JOB NAME: YC SHORT TERM HOLD
 CONTINGENCY COST SUMMARY - No. C-11 (PR
 No. 4)
 DATE: 04.07.2025
 Sletten Construction, Inc.

Proposal Request

PROJECT: *(name and address)*
YCDF Short Term Hold Addition
Billings, MT

Architect's Project Number: 2403
Proposal Request Number: 4
Proposal Request Date: 3/7/2025

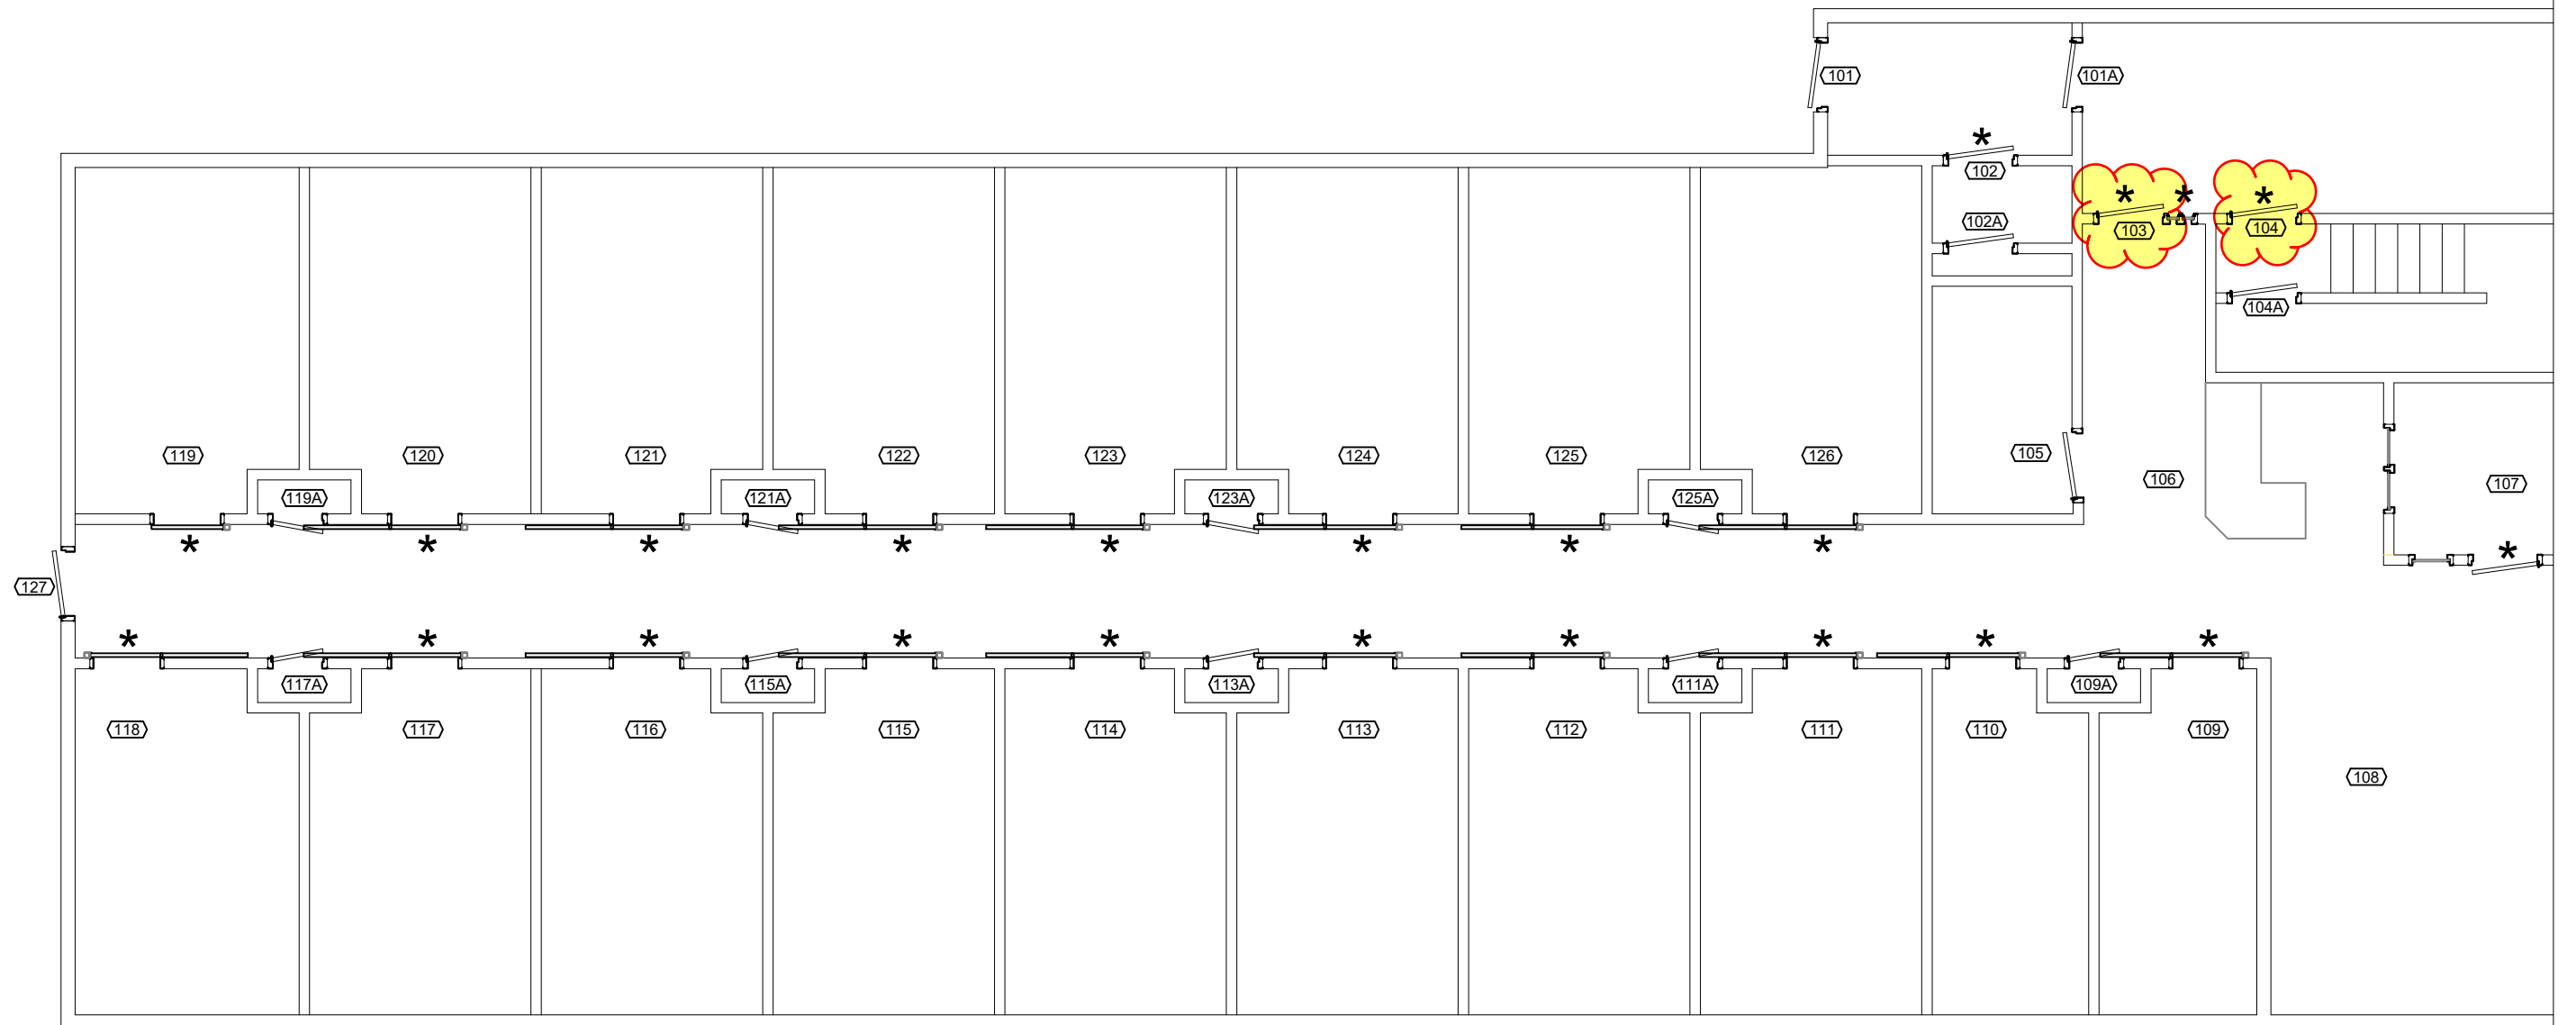
Doors 103, 104 and 203: Modify hardware sets to delete current manual hardware. Provide new Southern Folger 10300E-2-LEK Solenoid Operated Electro-Mechanical Deadlatch.

Prep frames for this jamb mounted modification.

V300 has been priced as equal/alternate

Provide surface mounted power with security fasteners to sally 103 side at Door 103 and inside Stair 104 for Doors 104 and 203.

DESCRIPTION: Floor Plan - MAIN FLOOR		JOB #: 0000
JOB NAME: Yellowstone County Expansion, MT		
REVISION #: 2	DRAWN BY: Jay Golliver	PART #:
DATE: 01/29/2025	SCALE: 1:X	SHEET: Floor Plan-1

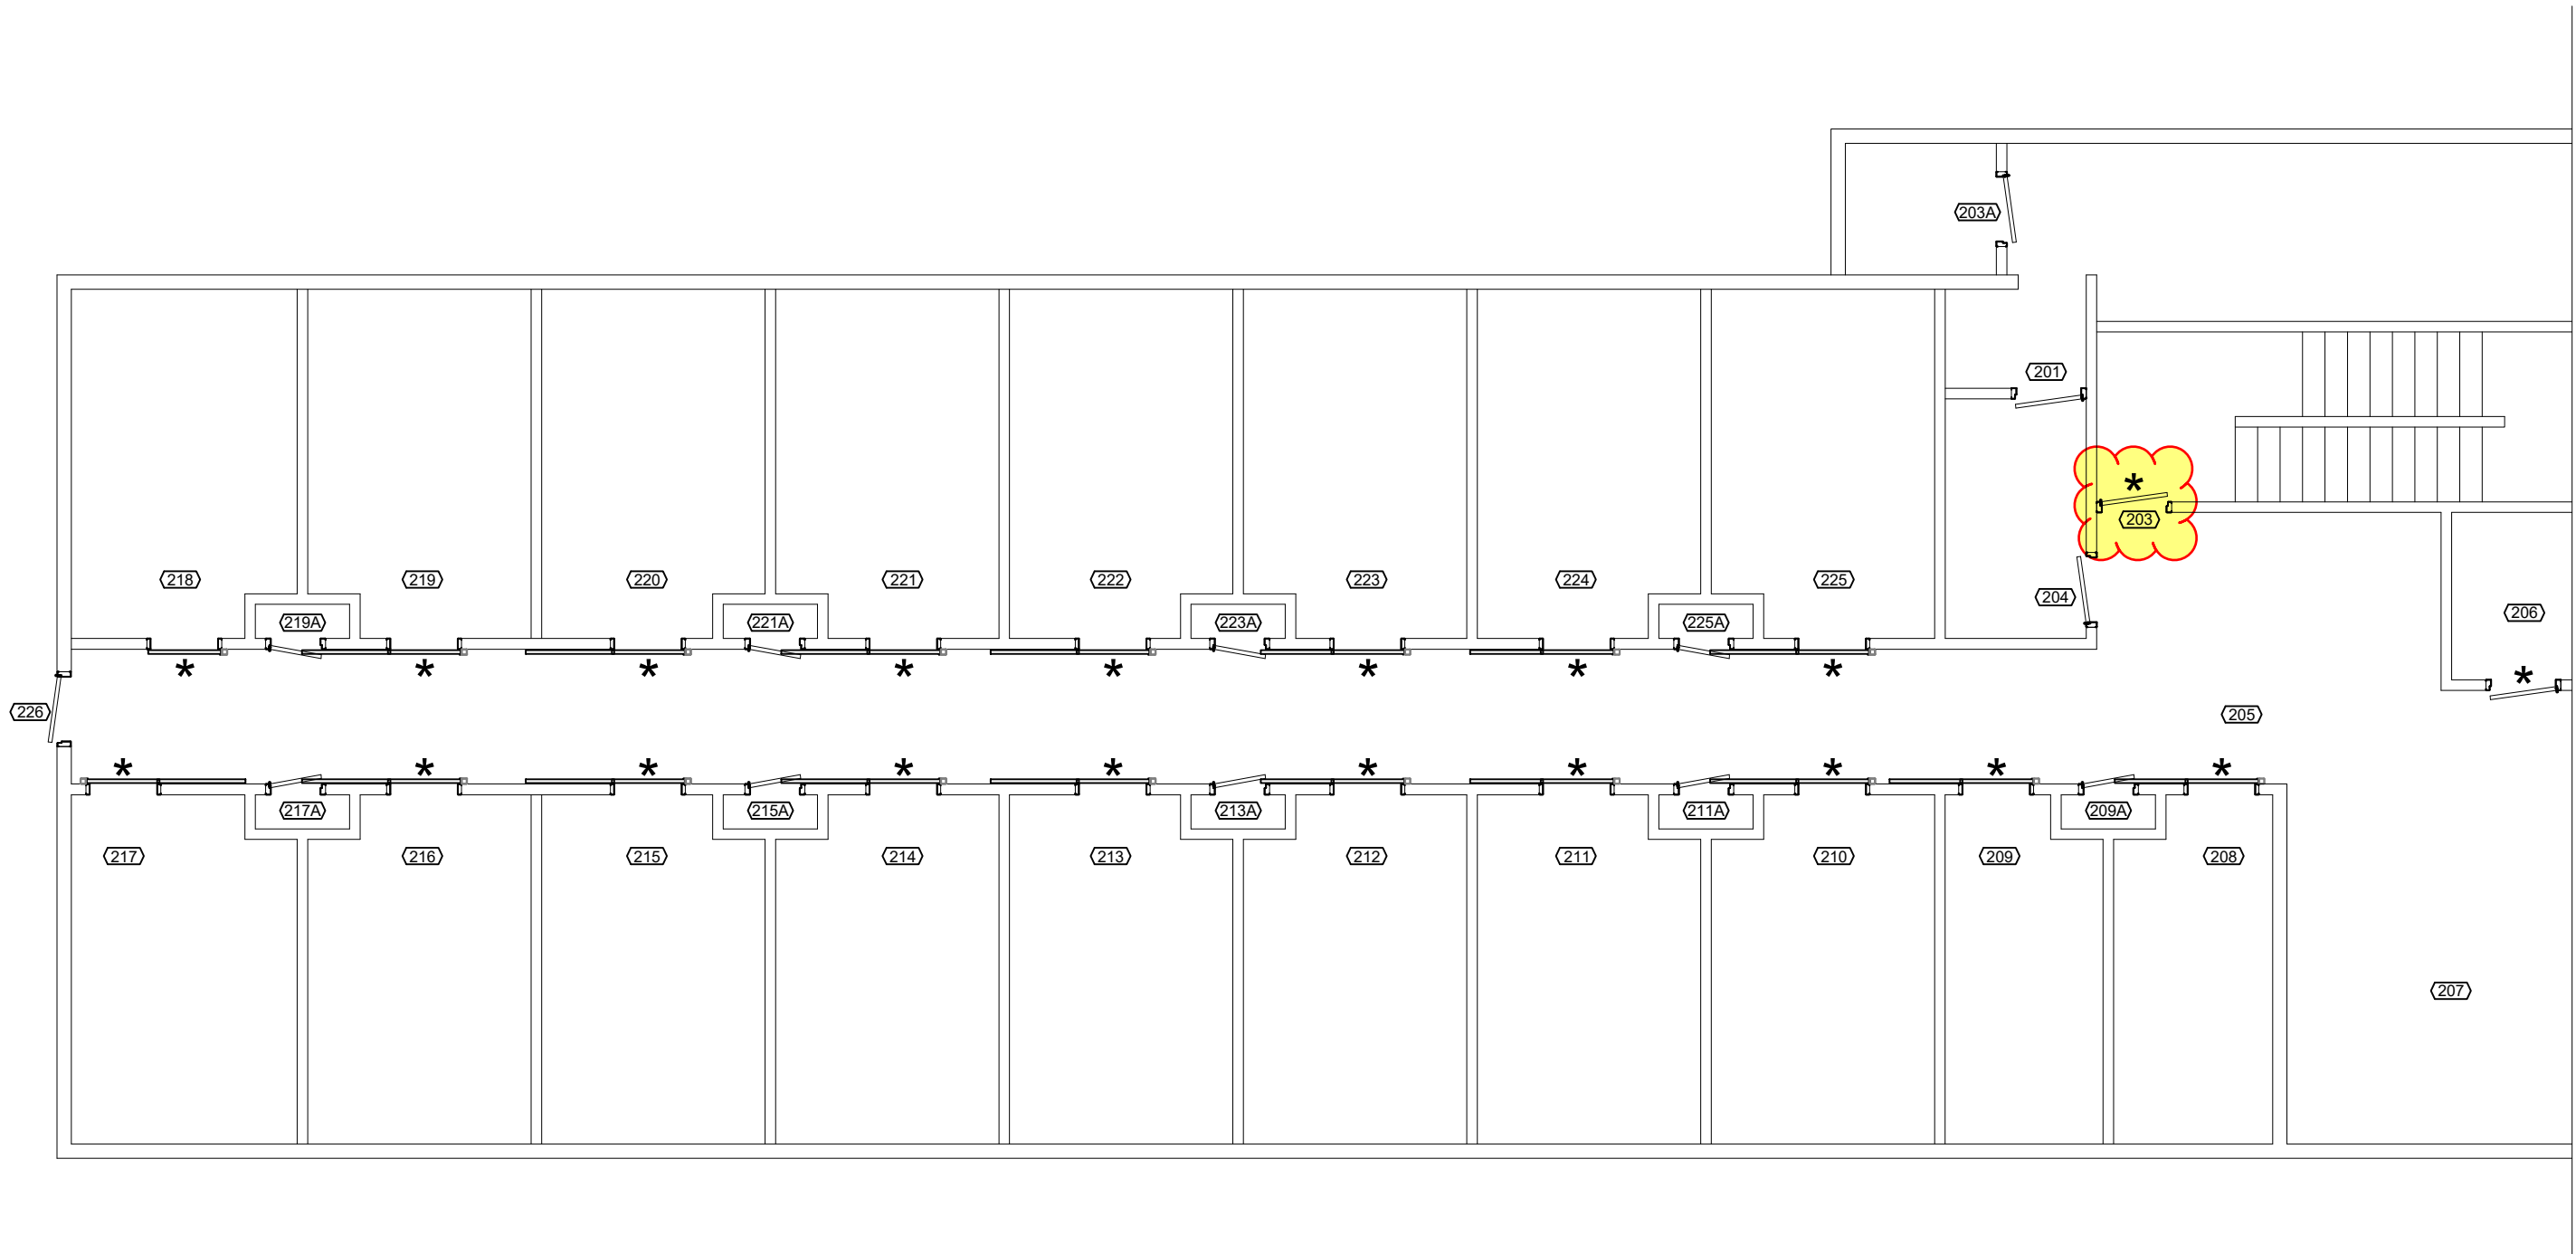
1	Automatic Deadlock	Viking	V30 Automatic Deadlock
Hardware Group #9			
<i>Openings: 203</i>			
1	Solenoid Operated Electro-Mechanical Deadlatch	Viking	V300
1	Cylinder (High Security Builder)	Assa Abloy	Maximum +
3	Hinge	Viking	204 FM-VP
1	Raised Pull	Viking	212C
1	Recessed Pull	Viking	Integral with Door
1	Wall Stop	IVES	FS18L
1	Head + Jamb Gaskets	PEMKO	290DV
1	DPS	Detex	MS-2049F
Hardware Group #10			
<i>Openings: 104</i>			
1	Solenoid Operated Electro-Mechanical Deadlatch	Viking	V300
1	Cylinder (High Security Builder)	Assa Abloy	Maximum +
1	Egress Push Button	Viking	Electric Push Button Release
1	Overhead Stop	Glynn Johnson	Series 90
3	Hinge	Viking	204 FM-VP
1	Closer	LCN	2215
1	Head + Jamb Gaskets	PEMKO	290DV
1	DPS	Detex	MS-2049F
